Environmental Impact Report

DEP No. 89-1222
SCH No. 91061052

SUBJECT: Rancho Peñasquitos Community Plan Update. COMMUNITY PLAN AMENDMENT, AMENDMENT TO THE CITY OF SAN DIEGO PROGRESS GUIDE AND GENERAL PLAN, and related REZONES for the purpose of updating the currently adopted Peñasquitos East Community Plan text and land use plan (now referred to as the Rancho Peñasquitos Community Plan). The update involves comprehensive revisions to the community plan text and land use plan, including updating the existing conditions discussion, re-evaluating certain land use designations, and expanding the discussion of resource management. Rezoning proposals include applying the Institutional Overlay Zone to public facilities, applying the Community Plan Implementation Overlay Zone to some commercially-designated sites, and possibly downzoning certain undeveloped areas currently included within the Hillside Review Overlay Zone. The update also proposes to delete from the plan the proposal to extend Camino Ruiz across Los Peñasquitos Canyon, resulting in the need to amend the General Plan. The Rancho Peñasquitos Community, which encompasses approximately 6,500 acres, is located immediately to t

Figure
A

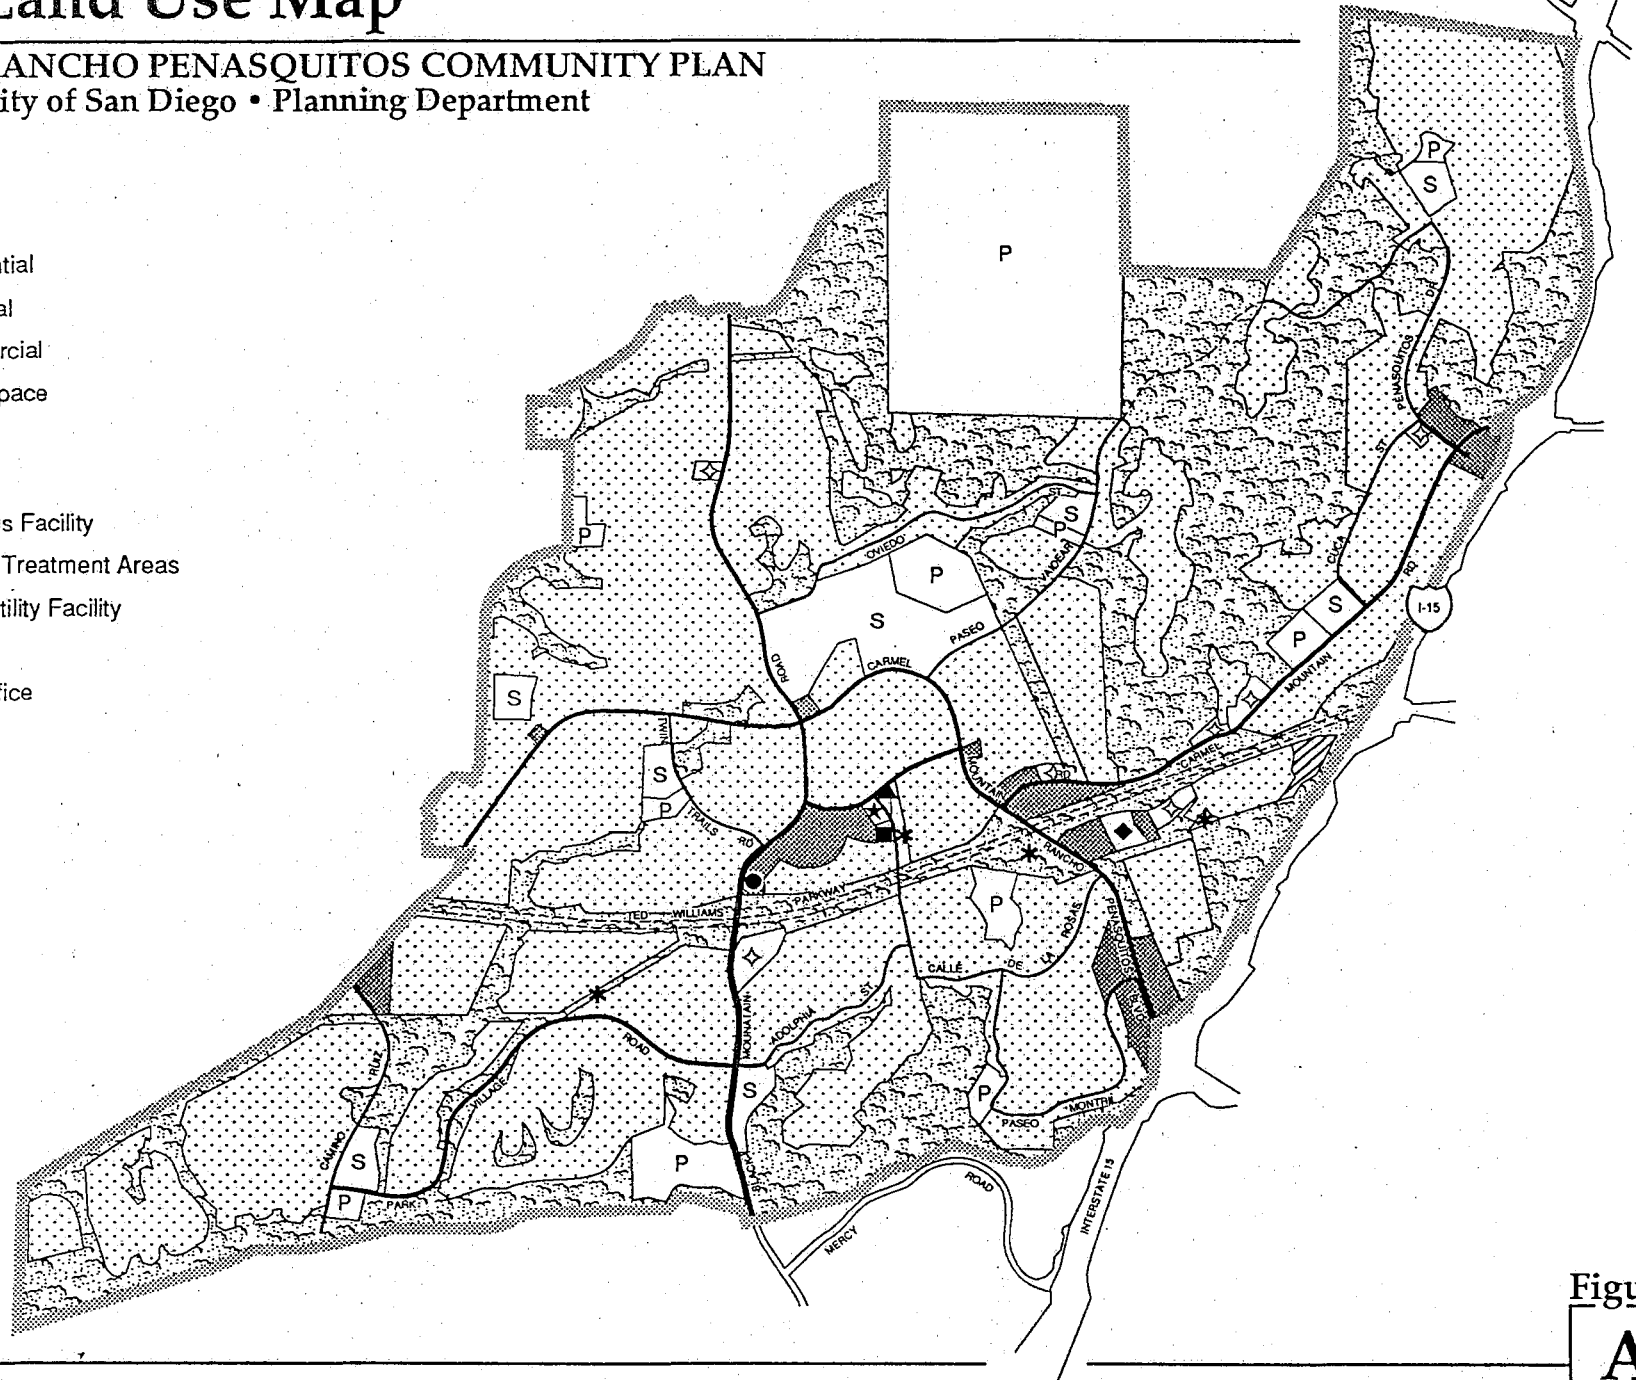
Subsequent to public review of the draft EIR, there were several changes to the draft Plan. A summary of the changes and the revised land use plan (Figure A) follows these conclusions. Based on the Plan revisions, some of the draft conclusions of potential environmental impacts have changed.

3. Neighborhood Element: In the Black Mountain neighborhood the configuration of open space and low density residential development has been reconfigured in response to the deletion of "J" Street. In the northeastern area of the Black Mountain neighborhood designated for residential development, all development has been designated outside the Hillside Review Overlay Zone. The density permitted in this area is reduced from the July 1991 draft Plan by approximately one-half. In the Ridgewood neighborhood, the proposed pedestrian bridge over Black Mountain Road has been deleted.

Figure

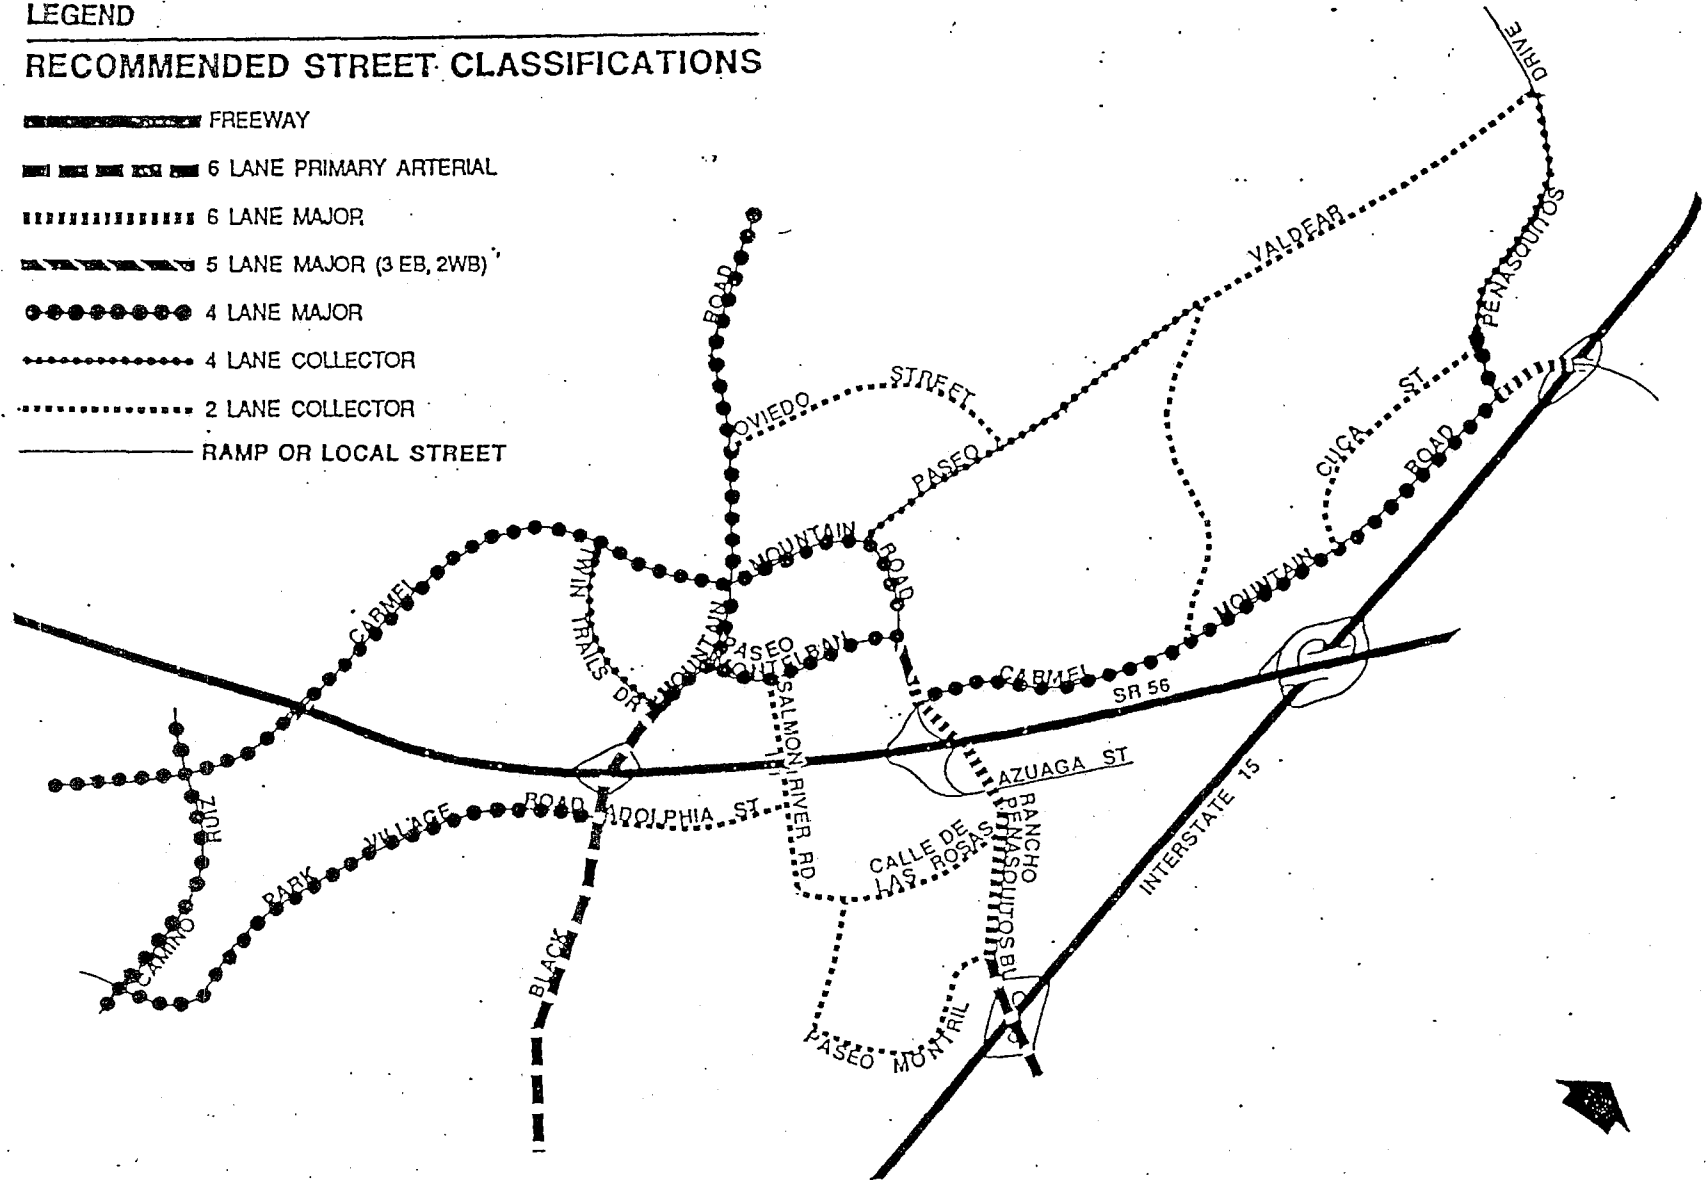
5.5 Figure 6, at page 14, illustrates the average daily trips ("ADT") "based on build-out of the community with development according to the community plan update." Because the Draft EIR incorrectly identified the allowable development densities under the proposed Update, City staff should explain what development densities were utilized in preparing Figure 6. Figure 6 should also contain a reference to the "source" for the ADT information.

A study of Figure 6 of the draft EIR (see attached) which shows traffic counts on that section of Camino Ruiz to be 8,000 ADT at build out.

If the Section of Camino Ruiz in Penasquitos Creek Neighborhood were to be eliminated all of the eight thousand ADT on Camino Ruiz would be dumped on Black Mountain Road at Park Village Road. Black Mountain Road will already be at 70,000 ADT on this section according to Figure 6 of the draft EIR (see attached).

31. Figure 6 was prepared by the City Engineering & Development Department, the source of all the community plan traffic analyses and recommendations. It was based on current information provided by the Long Range Planning Division to E&DD. It is assumed that E&DD was provided with accurate information and the illustration in Figure 6 is accurate. The EIR Project Description section has been revised to reflect consistent densities.

Figure

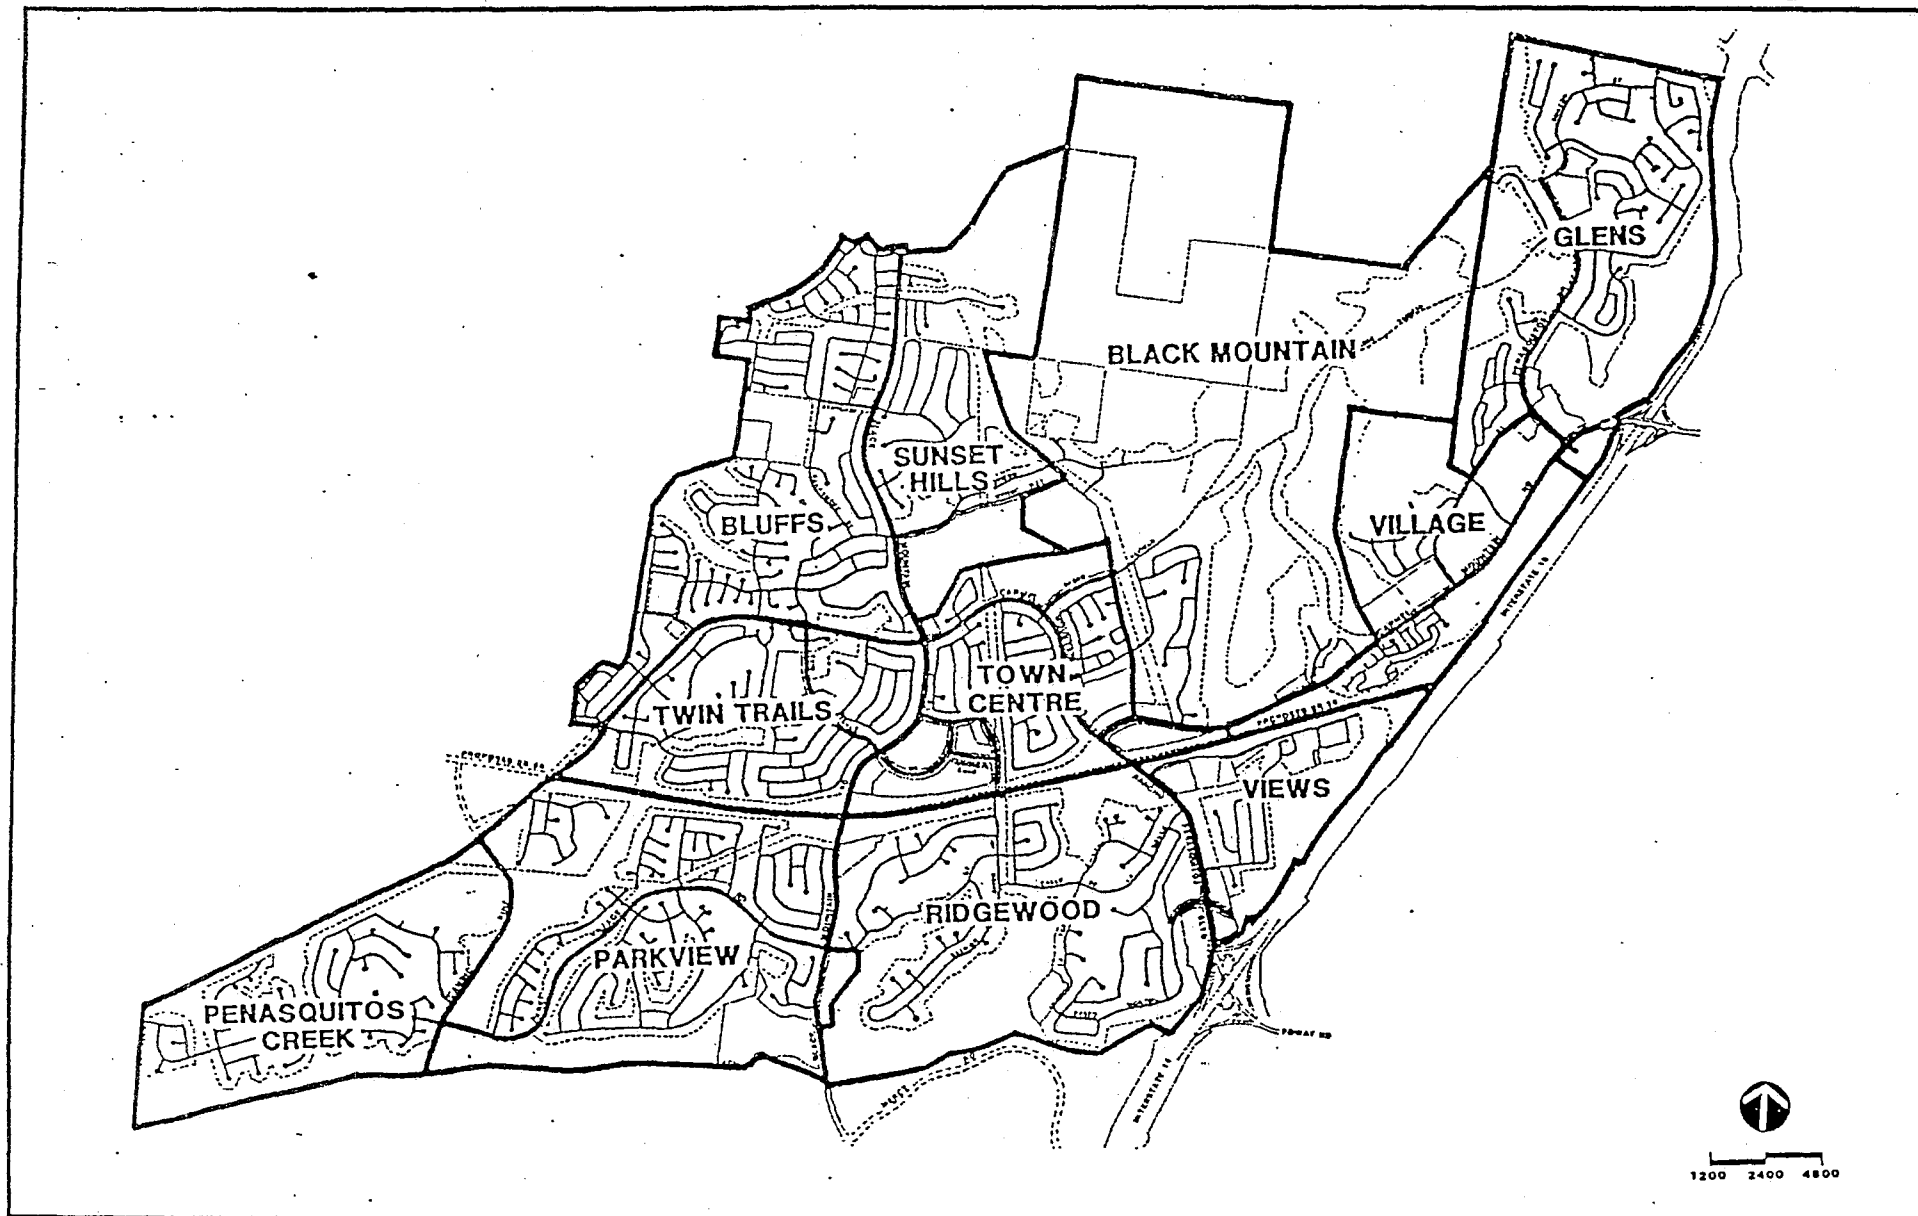
Figure 7, page 15 - Change Carmel Mountain Road six lane major street designation north of Rancho Penasquitos Boulevard to five lane major. Change Rancho Penasquitos Boulevard to five lane major between Carmel Mountain Road and Azuaga Street, and change to four lane major between Azuaga Street and I-15.

The graphic (Figure 7) showing recommended street classifications needs to be corrected to show Carmel Mountain Road between Penasquitos Drive and Interstate 15 as a six-lane prime arterial instead of a six-lane major street. Carmel Mountain Road should be shown as a six-lane major street between Paseo Montalban and Rancho Penasquitos Boulevard.

153. Based on revised recommendations from E&DD, the EIR has been revised to change the ultimate designation of Carmel Mountain Road to a five-lane major with three eastbound and two westbound lanes. In addition, E&DD's recommendation is to improve Rancho Penasquitos Boulevard to a five-lane major between Carmel Mountain Road and Azuaga Street. Figure 7 shows recommended street classifications. (Refer to memo from E&DD included in comments).
